EL PASO COUNTY FILE NO.: PUD SP-22-006

# VILLAGES AT STERLING RANCH

## DEVELOPMENT PLAN & PRELIMINARY PLAN

# V3\_PUD Development Plan - v3 new design comments.pdf Markup Summary

**TYPICAL LOT CONFIGURATION DETAIL – ADU**  
**PRIVATE STREET**  
 AMES HEIGHTS, JANESVILLE HEIGHTS, MILWAUKEE HEIGHTS  
 SCALE: 1"=20' (H)  
 (DETACHED SINGLE FAMILY)  
**LOTS 67-92**

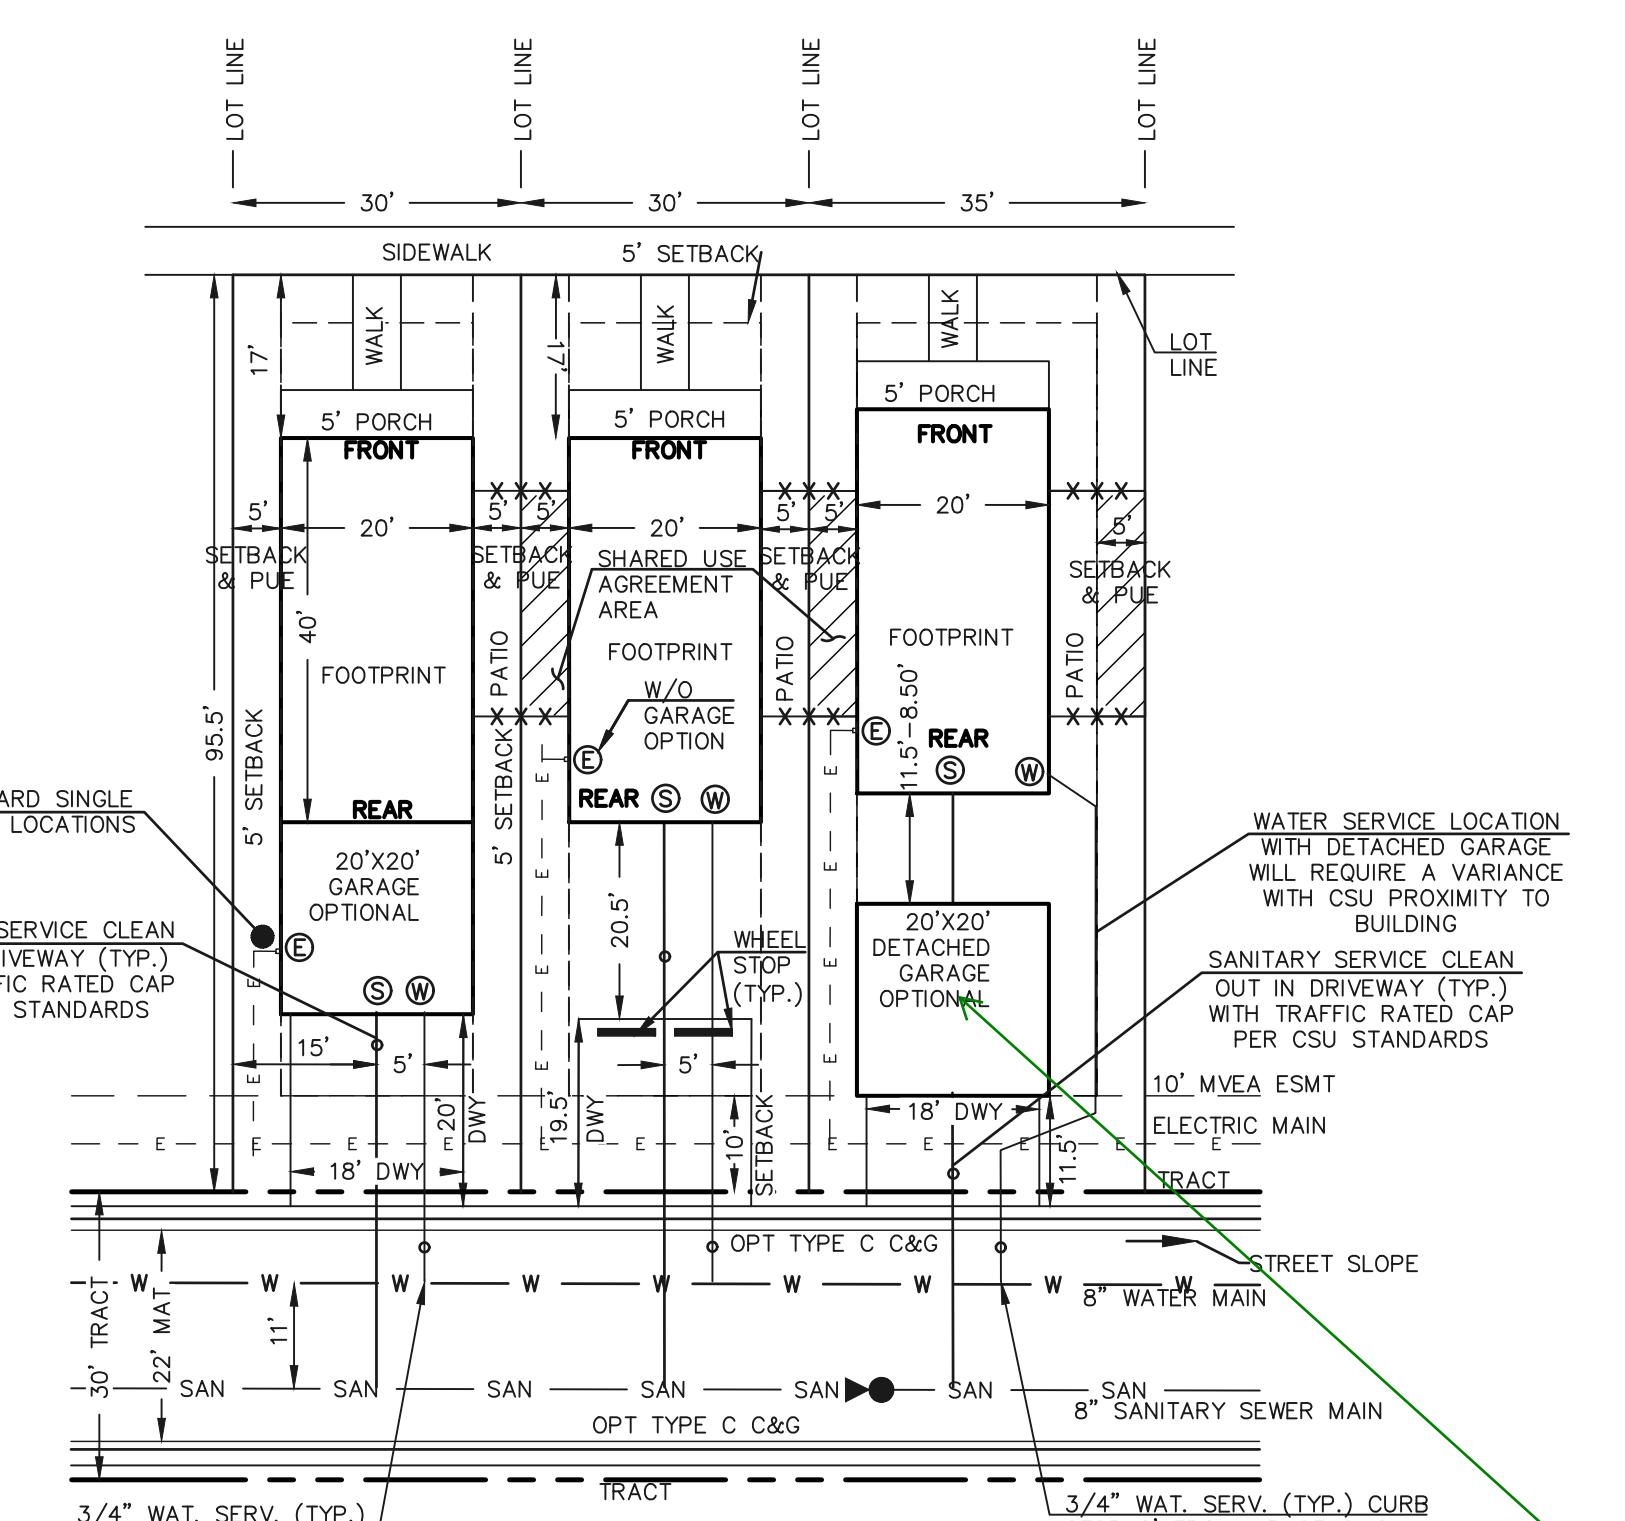
there is no site plan at this stage. A site plan is at time of building permit for each unit home. Parking has to be shown here. This is the PUD Development Plan.

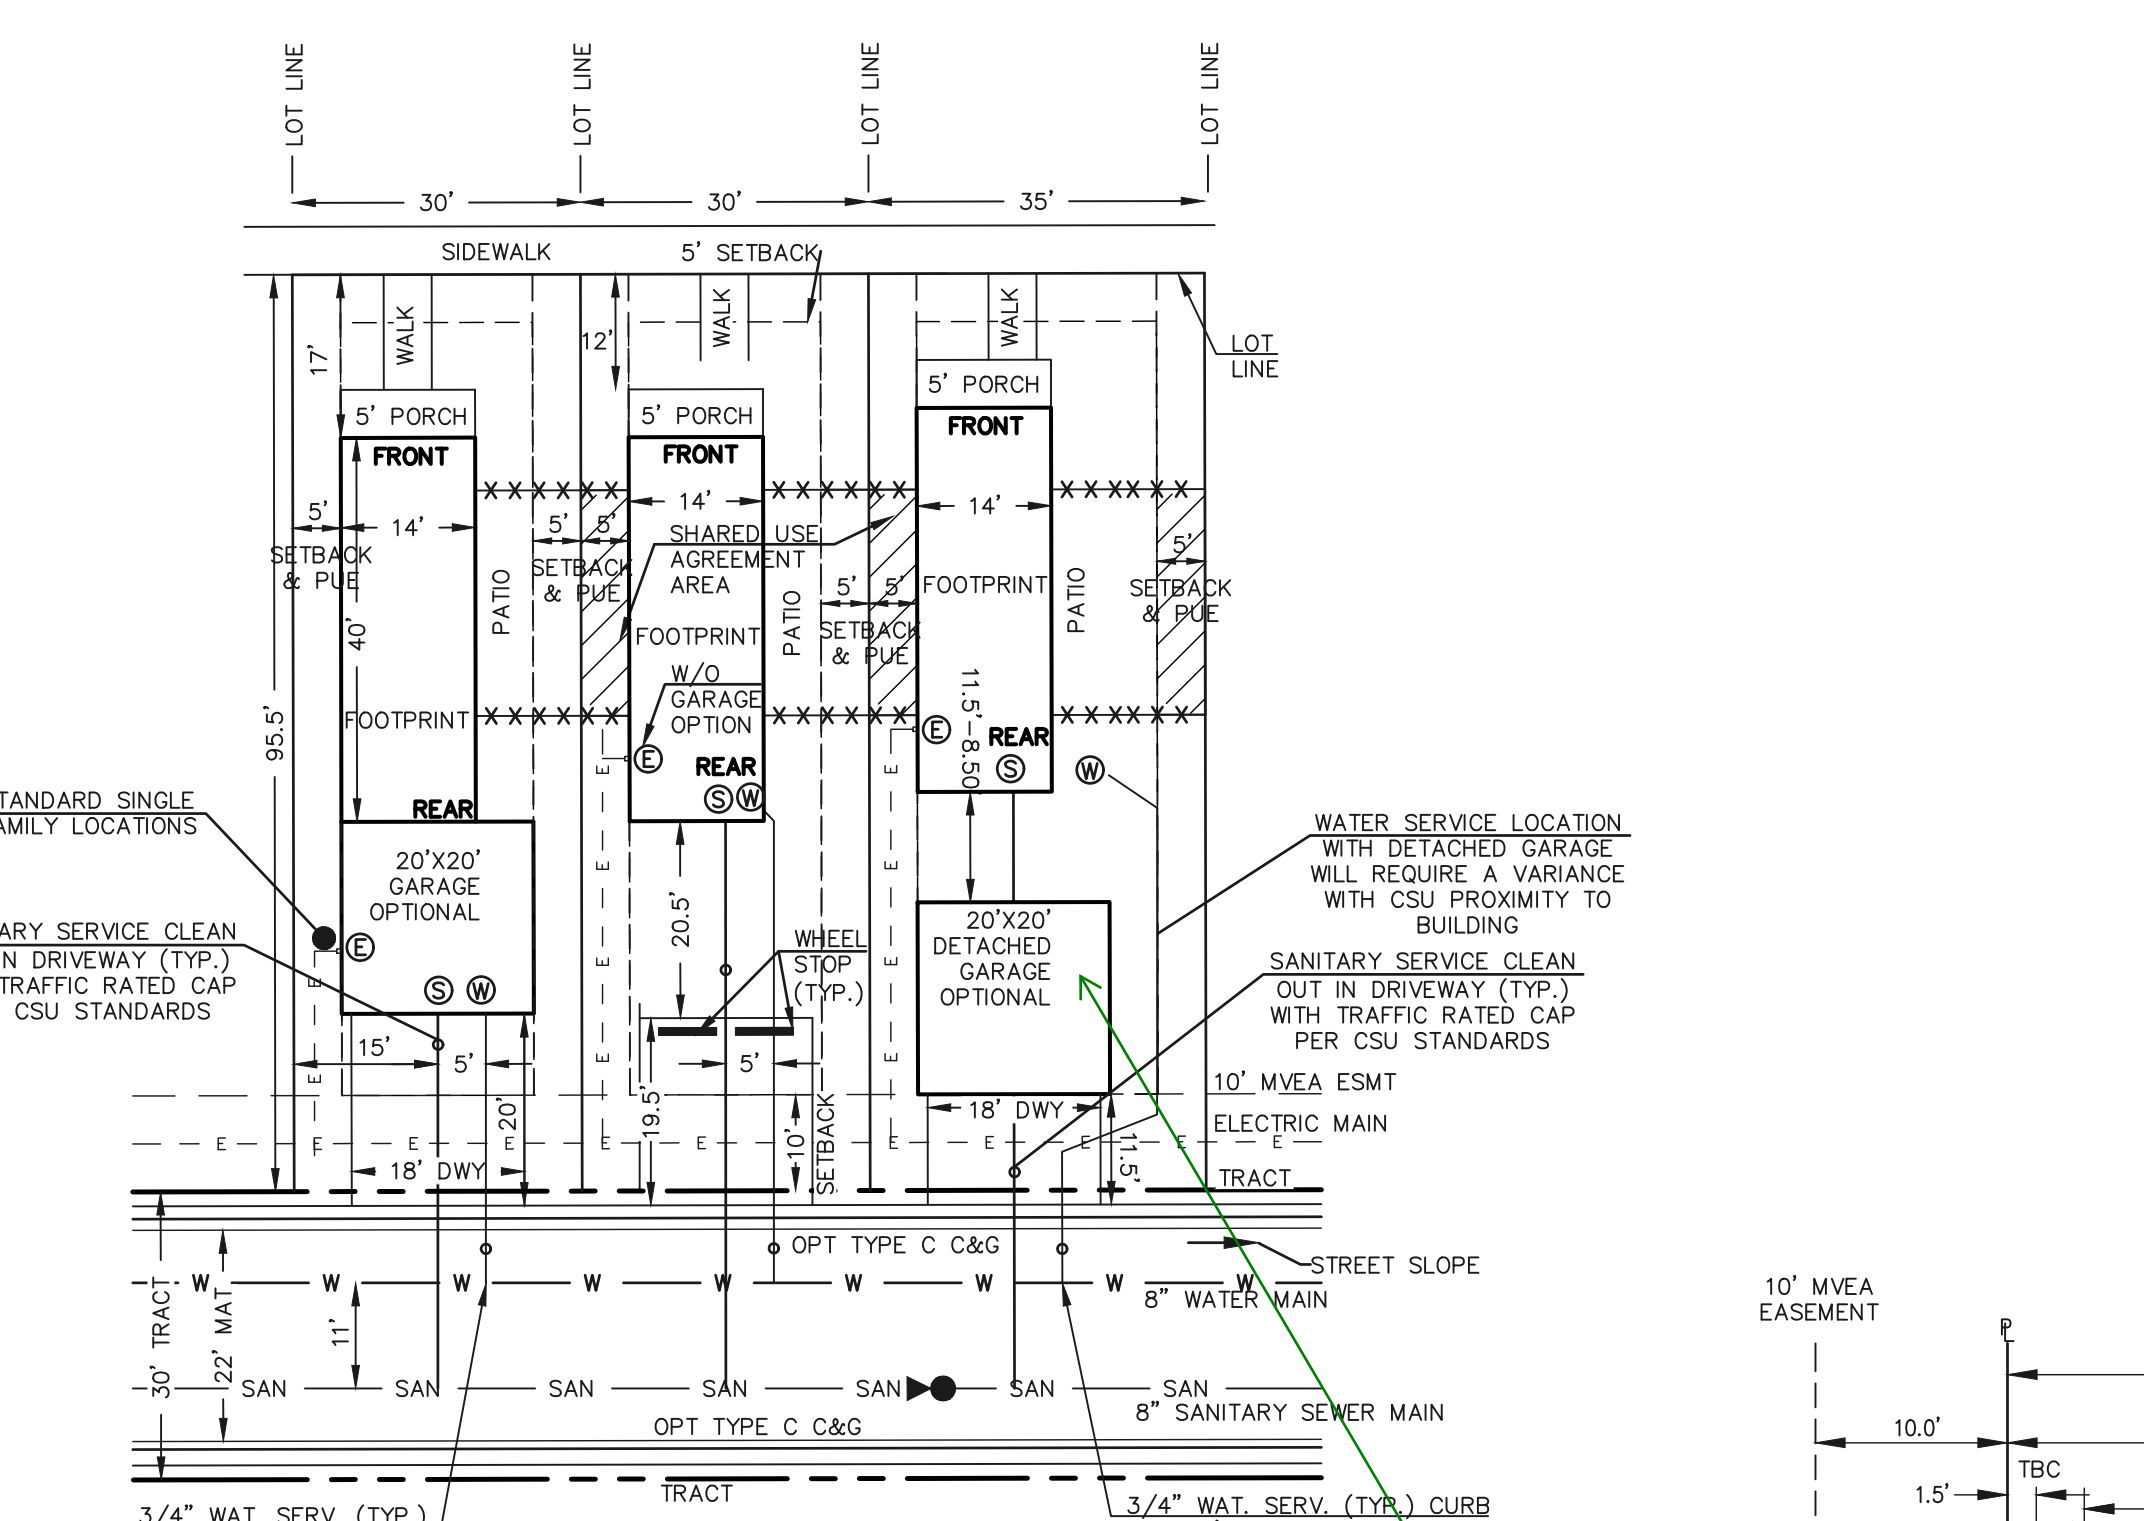
I am confused on where the driveway parking is on this details. If these are turned into ADU is there no parking for main home or 2cd home

there is no site plan at this stage. A site plan is at time of building permit for each unit home. Parking has to be shown here. This is the PUD Development Plan.

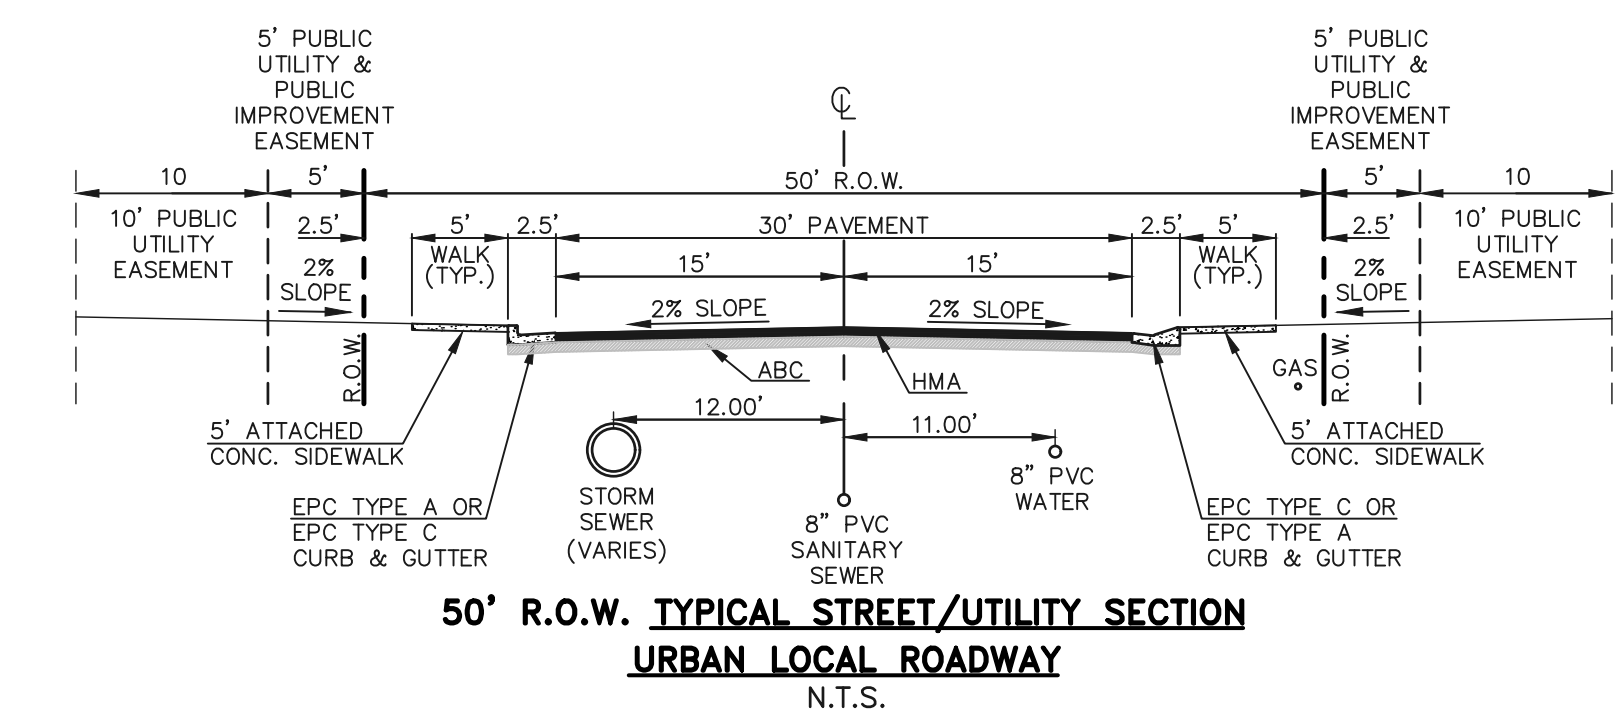
I am confused on where the driveway parking is on this details. If these are turned into ADU is there no parking for main home or 2cd home

**30' ROAD RESIDENTIAL (ACCESS) PRIVATE TRACT**  
 N.T.S.  
 NO PARKING ALLOWED

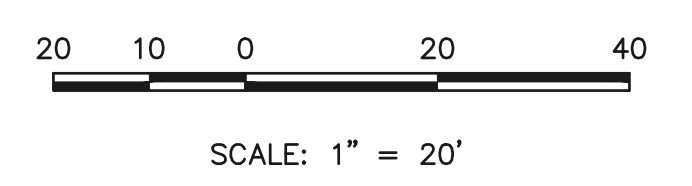
where are the signs to be located depicting no parking - use symbol on PUD Plan

PUD DEVELOPMENT PLAN  
& PRELIMINARY PLAN

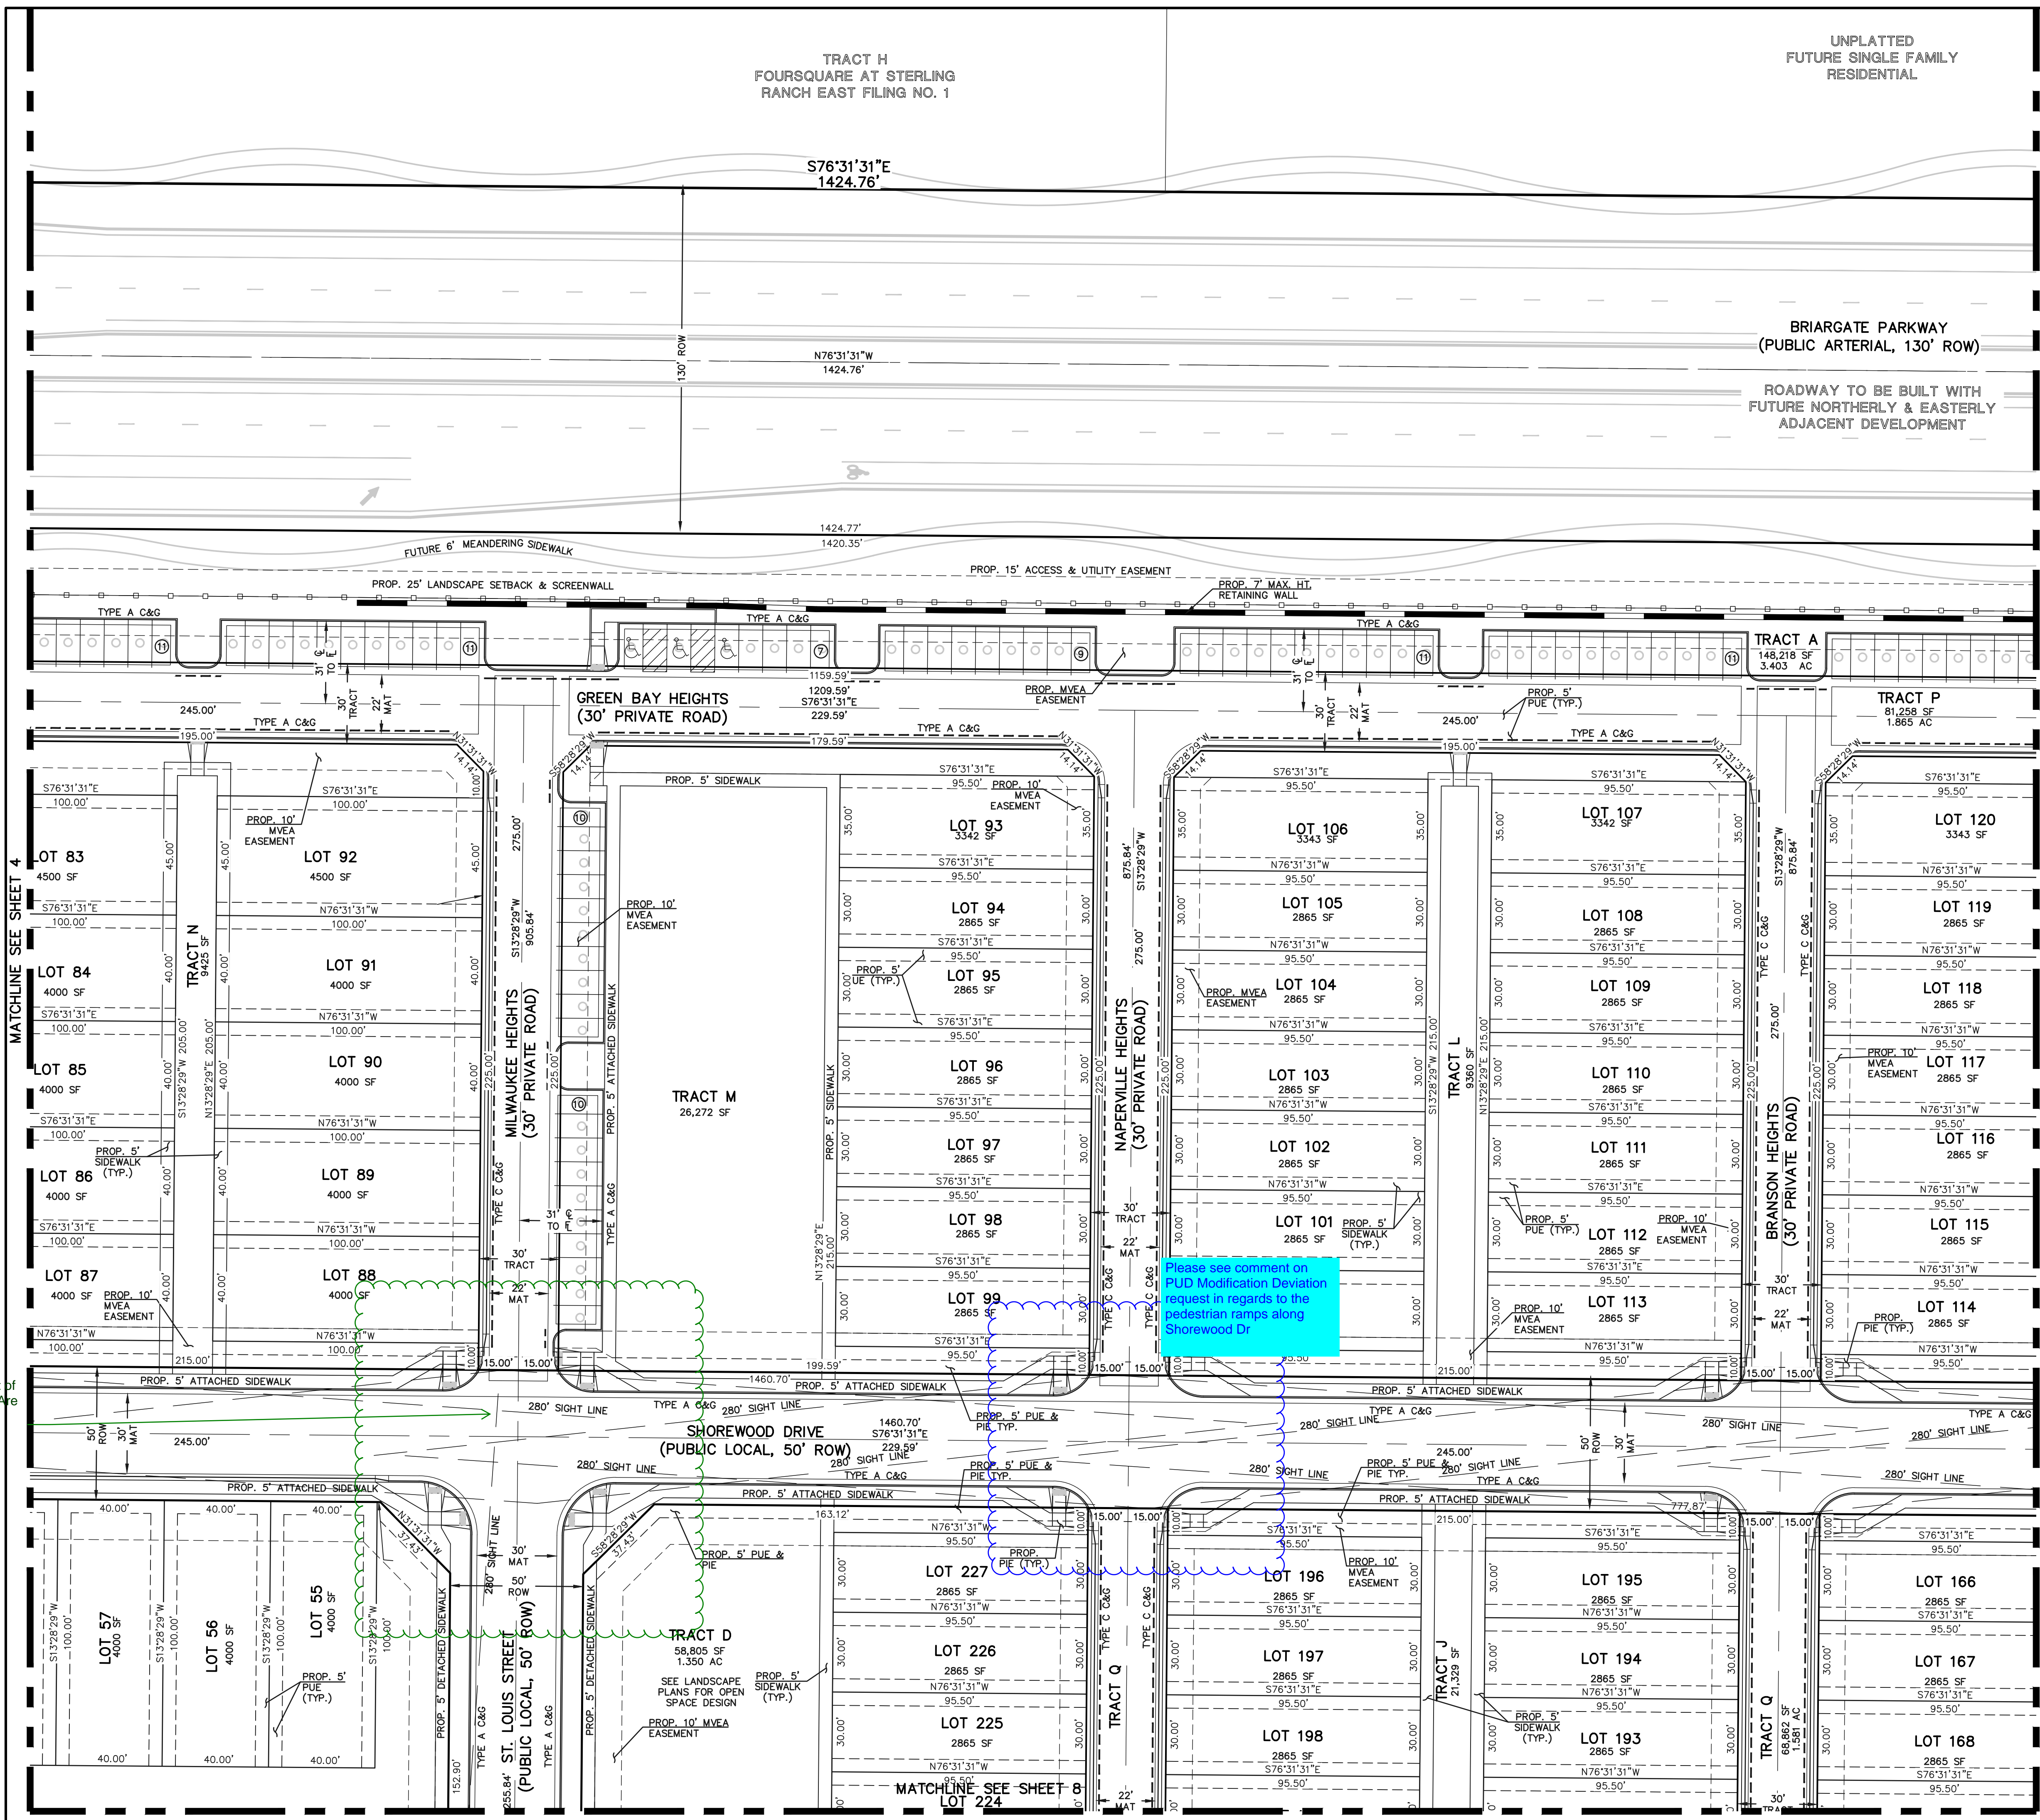
Please see comment on PUD Modification Deviation request in regards to the pedestrian ramps along Shorewood Dr

Are the homes out of the site triangle? Are larger setbacks needed for lots on Corners of public ROW
